**STAFF RECOMMENDATION**

**2510 Fairfax Avenue**

**May 19, 2021**

**Application:** New Construction—Addition; Setback Determination; Partial Demolition

**PROPOSED  
SITE PLAN**

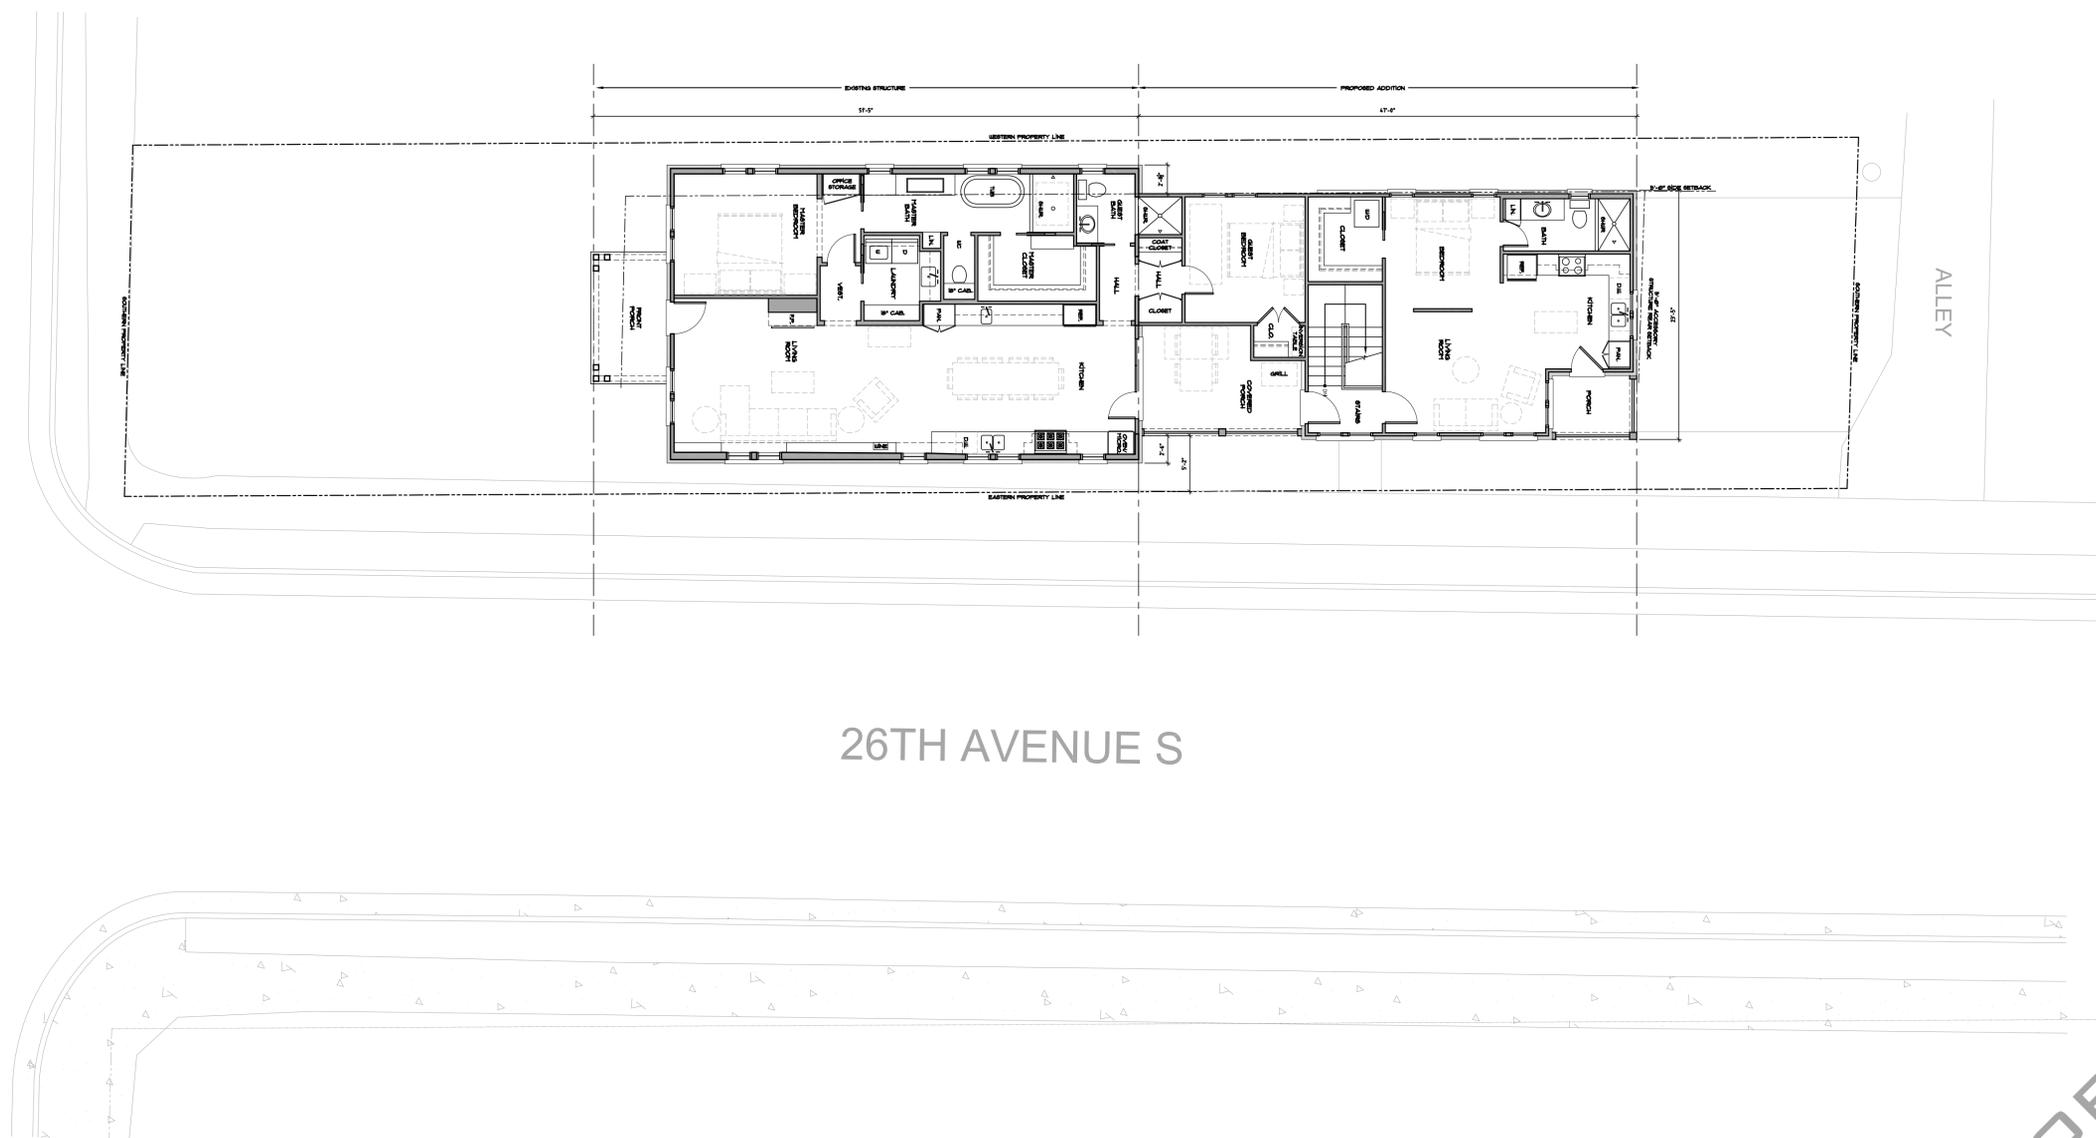
Setback & Rhythm of Spacing: The addition is located five feet (5') from the left-side property line and twenty feet (20') from the rear property line, which meets the design guidelines. The minimum street setback from 26<sup>th</sup> Avenue South is ten feet (10') per the zoning code; however, the applicant requests to reduce the setback to five feet, two inches (5'-2"). Staff finds that the requested setback determination can be appropriate given the narrowness of the lot, which is only thirty-three feet (33') wide, along with the appropriately scaled addition that is no closer to the street than the historic house.

Staff finds that the proposed setback determination is appropriate for this location and that the project meets Section II.B.1.c.

**EXTERIOR  
ELEVATIONS**

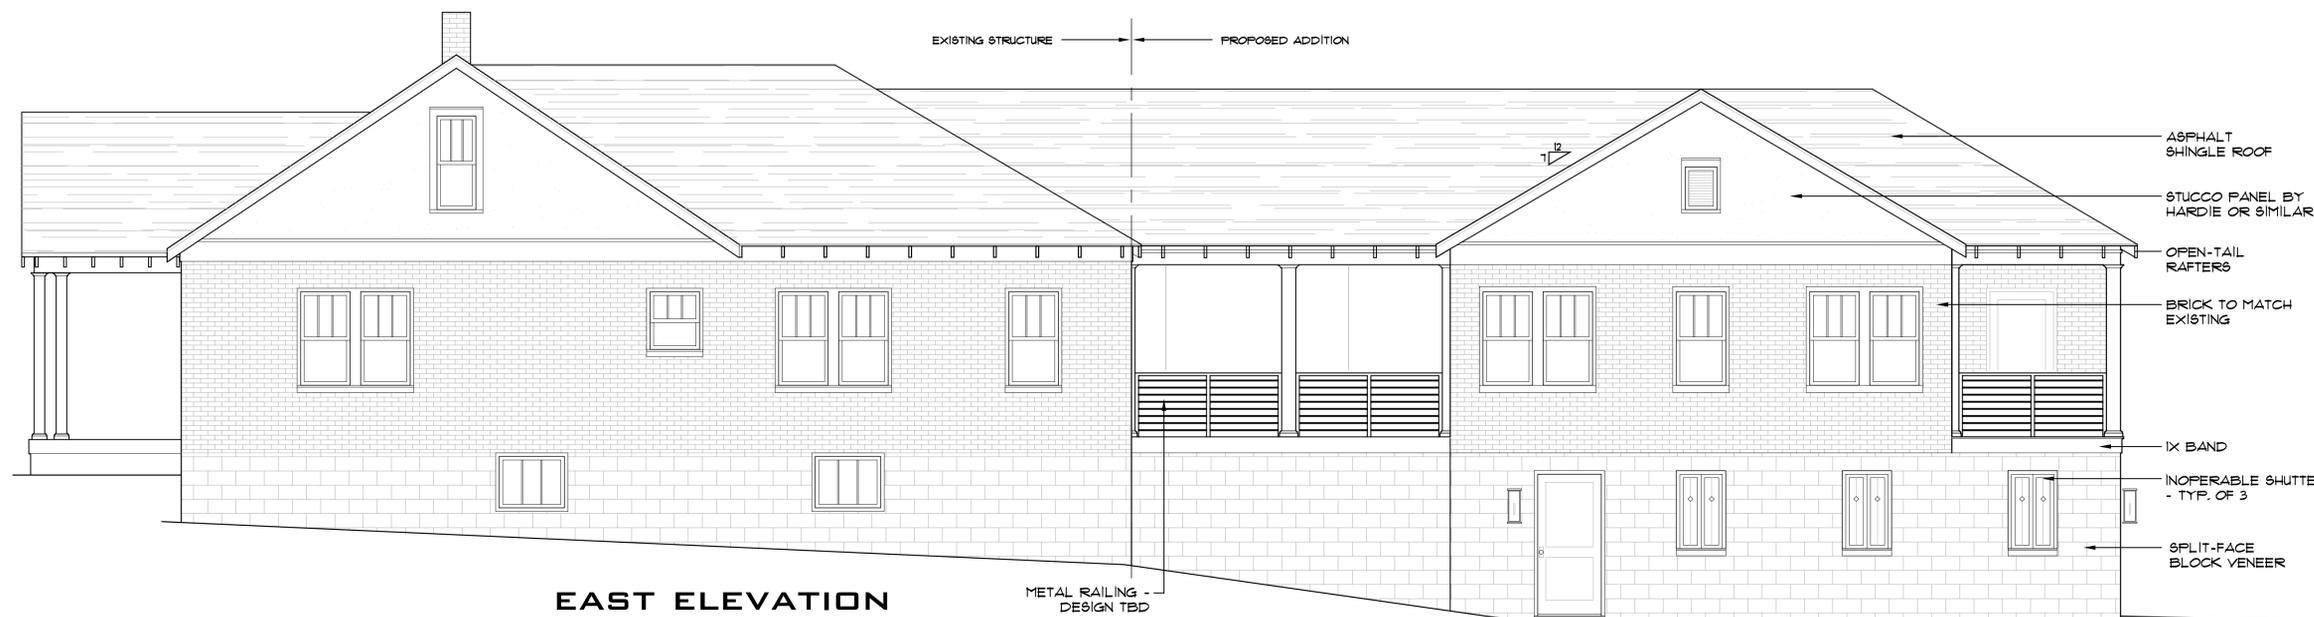
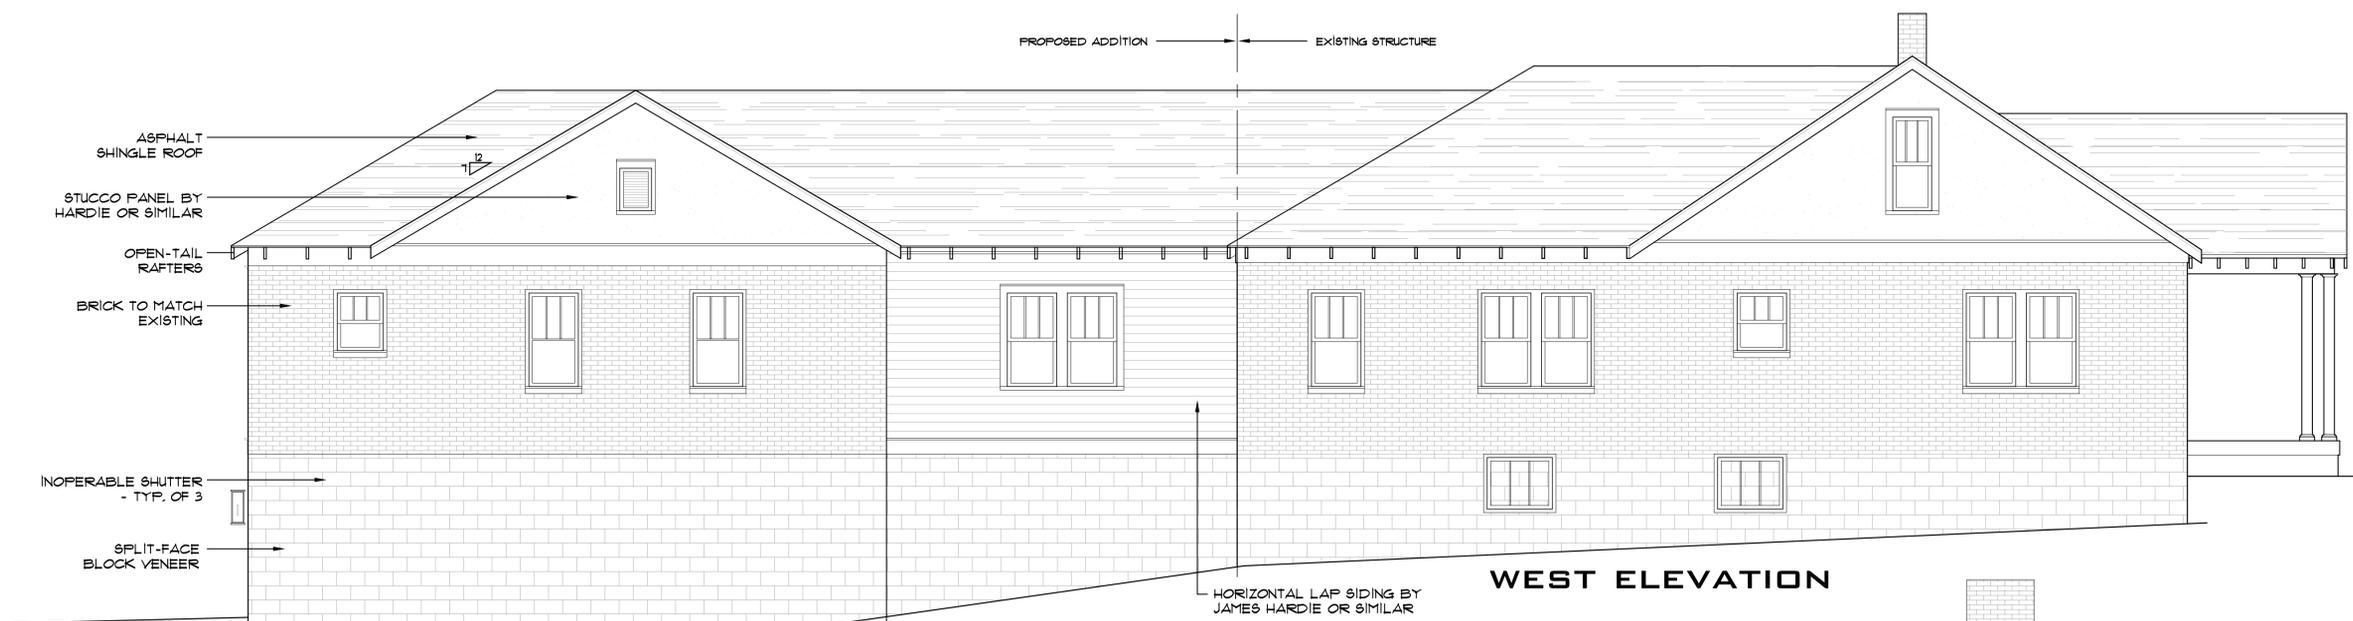
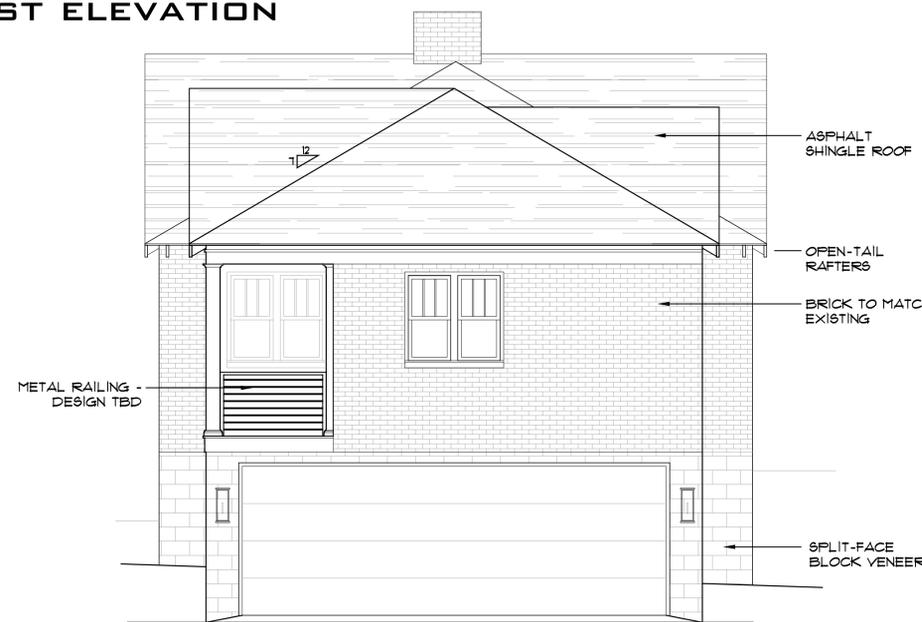
The addition is clad in Hardie siding and brick with stucco in the gable fields. The details of the siding were not noted; the siding should have a smooth finish and maximum reveal of five inches (5”) to meet the design guidelines. With the condition that staff review the final selections of the roof color, brick, trim, porch floor, porch posts, windows, and doors prior to purchase and installation, staff finds that the project meets Section II.B.1.d.

**Roof Form:** The addition ties in below the existing hipped roof form on the historic house with a hipped form that incorporates side gables. Both roof forms on the addition have a 7/12 pitch which is the same as the pitch of the hipped portion of the existing house. Staff finds that the roof form of the addition is compatible with that of the historic house and that the project meets Section II.B.1.e.

**Proportion and Rhythm of Openings:** No changes to the window and door openings on the existing house were indicated on the plans. The windows on the proposed addition are all generally twice as tall as they are wide, thereby meeting the historic proportions of openings. There are no large expanses of wall space without a window or door opening. Staff finds the project’s proportion and rhythm of openings to meet Section II.B.1.g.

1. Staff approve the final details, dimensions and materials of roof color, trim, porch floor, porch posts, windows, and doors prior to purchase and installation;
2. Staff approve the masonry color, dimensions and texture;
3. The siding shall have a smooth finish and maximum reveal of five inches (5”); and
4. The HVAC shall be located behind the house or on either side, beyond the mid-point of the house, and utility meters shall be located on the side of the building, within 5’ of the front corner. Alternative mechanical and utility locations must be approved prior to an administrative sign-off on building permit(s).
